The purpose of this submittal is to provide a final grading plan and drainage management plan for the Redevelopment of 2301 Juan Tabo Blvd NE, located near the SWC of Juan Tabo and Menaul NW in Albuquerque, NM.

ARCHITECTS ARCHITECTS						
	CI-C2-11	SCALE AS SHOWN	PUF	10DD WEX 6892 55510W /12	/2		JTW V
SET REVISIONS	NO DESCRIPTION DATE DATE	1 INITIAL ISSUE 11-13-15 SCALE		CULET DEVISIONS		CKD	APPD
	NEW DUNKIN DONUTS 2301 JUAN TABO BLVD NE 1 INITI			1			PC NUMBER
	C,	1.1 -	Gı	radii	าต	Pla	an

From:	Rael, Rudy E.
Sent:	Friday, February 26, 2016 12:10 PM
To:	'jeffwooten.pe@gmail.com'
Cc:	Abiel X. Carrillo
Subject:	Dunkin Donuts

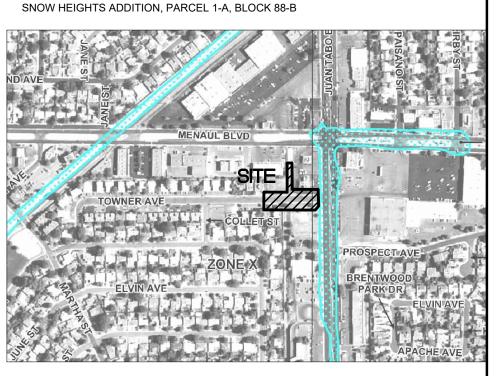
1. Trash enclosure needs drain attached to the SAS with a grease trap.

2. Build notes are needed for the pond and the sloped area by the driveway for erosion protection.

3. Bottom of pond needs erosion protection at the end of the entry channel.

4. Flow line/gutter elevation needed for the entry on Juan Tabo.

5. Extend the sidewalk culvert 1' passed the property line.
